UNITED STATES PATENT AND TRADEMARK OFFICE

APPLICATION NO.	FILING DATE	FIRST NAMED INVENTOR	ATTORNEY DOCKET NO.	CONFIRMATION NO.
09/640,038	08/16/2000	Christoph Dorr	TRW(EHR)05042	3171

**Office Action Summary**

## DETAILED ACTION

Fig.4

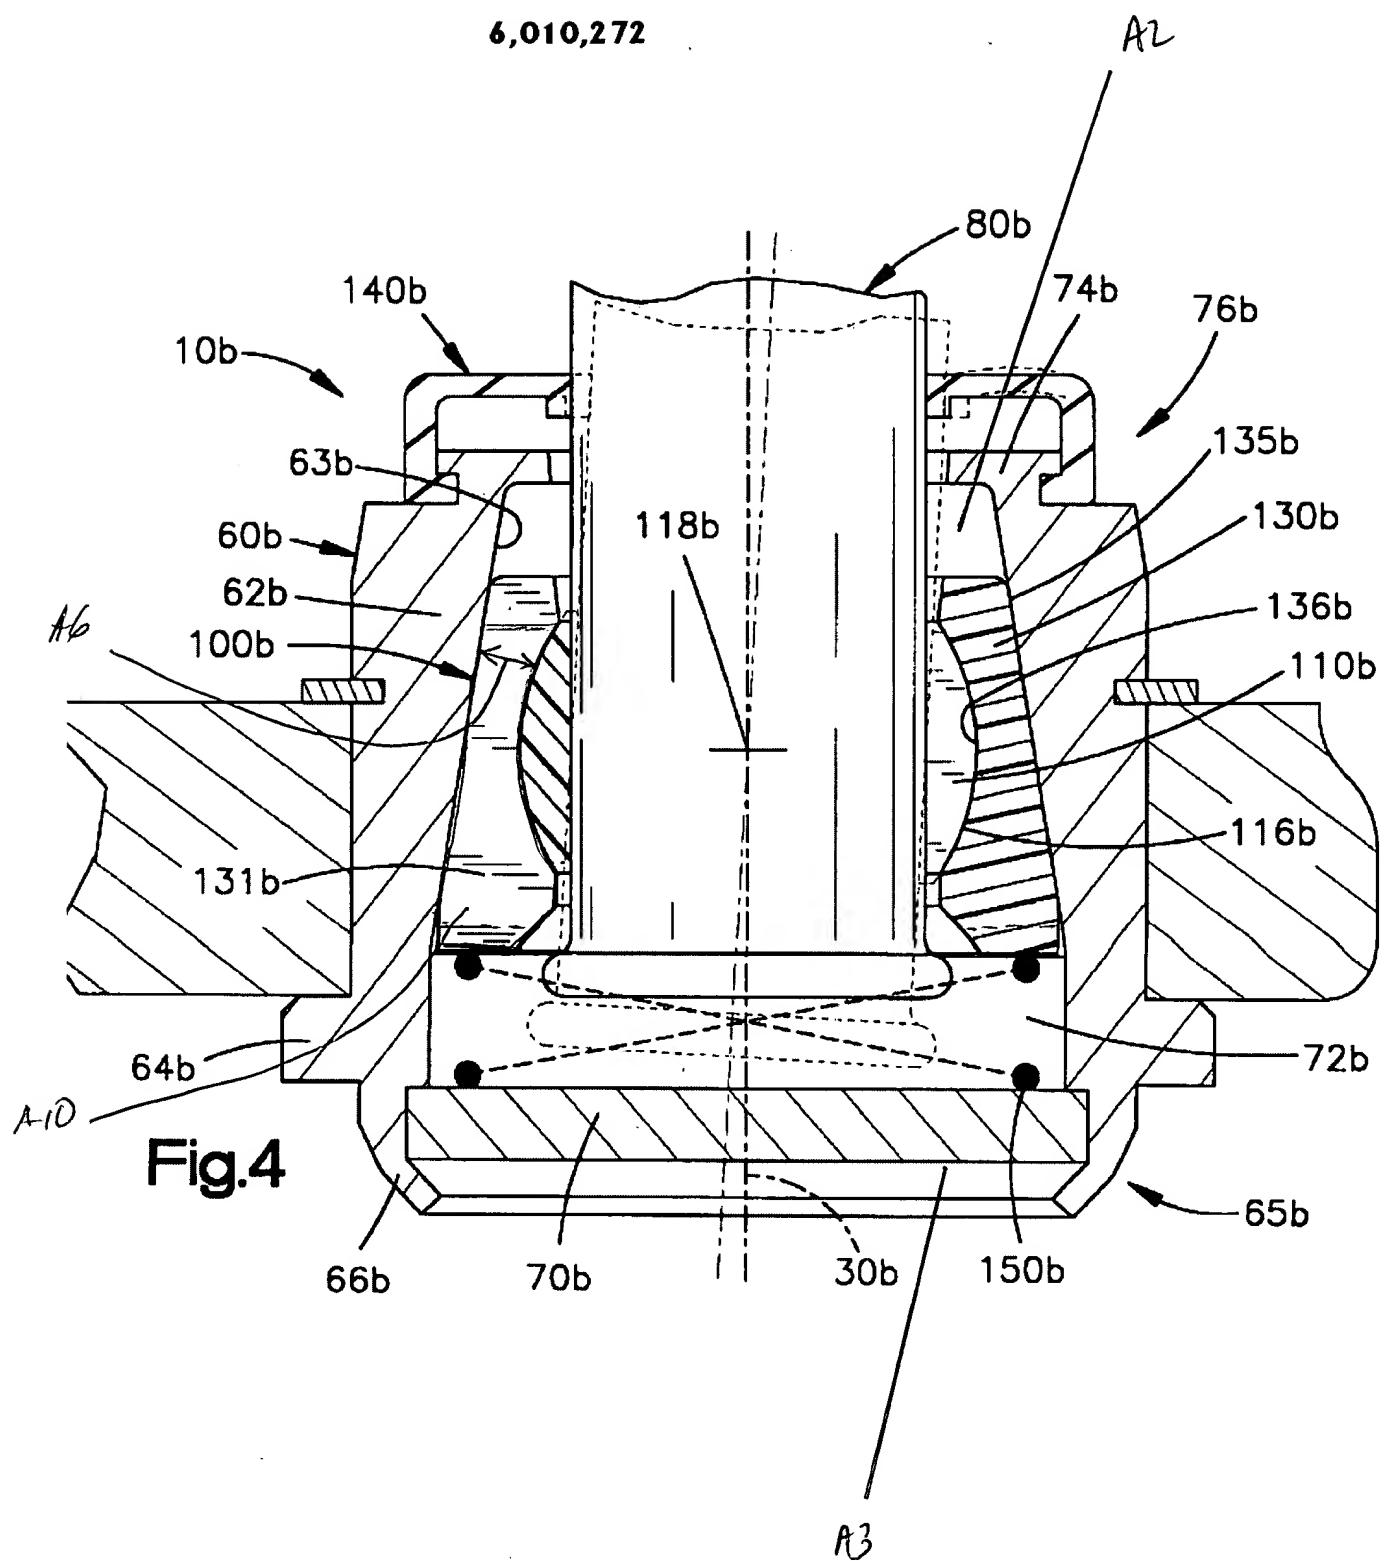
Claims 17, 18, 22 and 28 are rejected under 35 U.S.C. 102(e) as being anticipated by Littman, 6,010,272 (see marked-up attachment).

Regarding claim 17, Littman discloses in Figure 4 a ball-and-socket joint comprising a joint housing **60b**, a ball head **110b**, a bearing shell **130b**, a housing cover **70b**, and a structure **150b**. The joint housing **60b** has a first axial end **A2** and a second axial end **A3**. The ball head **110b** has a ball stud **80b** extending from the ball head **110b**. The ball head **110b** is received in the joint housing **60b**. The ball stud **80b** extends outward of the first axial end **A2**. A gap **A6** is formed between the ball head

**110b** and the joint housing **60b** adjacent the ball stud **80b** at the first axial end **A2**. The bearing shell **130b** is received in the joint housing **60b**. The structure **150b** is interposed between the housing cover **70b** and at least a portion **A10** of the bearing shell **130b** and the structure **150b** acts upon the portion **A10** of the bearing shell **130b**.

The bearing shell **130b** is for supporting the ball head **110b**. The ball head **110b** is for tilting relative to the joint housing **60b**. The housing cover **70b** is for closing the second axial end **A3** of the joint housing **60b**. The structure **150b** is for urging the portion **A10** toward the first axial end **A2** of the joint housing **60b**, in response to wear of the portion **A10** of the bearing shell **130b** and for wedging the portion of the bearing shell **130b** into the gap **A6**.

Regarding claim 18, the structure **150b** advances the portion **A10** of the bearing shell **130b** toward the first axial end **A2** for wedging the portion **A10** of the bearing shell **130b** further into the gap **A6** as wear to the portion **A10** occurs.

Regarding claim 22, the bearing shell **130b** includes a deformable area **136b**. Applicant is reminded that the recitation that an element is "adapted to" perform a function is not a positive limitation but only requires the ability to so perform. It does not constitute a limitation in any patentable sense. *In re Hutchison*, 69 USPQ 138.

Regarding claim 28, the portion **A10** of the bearing shell **130b** is cylinder-shaped (see dashed lines). Applicant is reminded that the method of deforming the portion of the bearing shell by an inner wall of the joint housing when assembled into the joint housing is not germane to the issue of patentability of the device itself. Therefore, this limitation has been given limited patentable weight. See MPEP ' 2113.
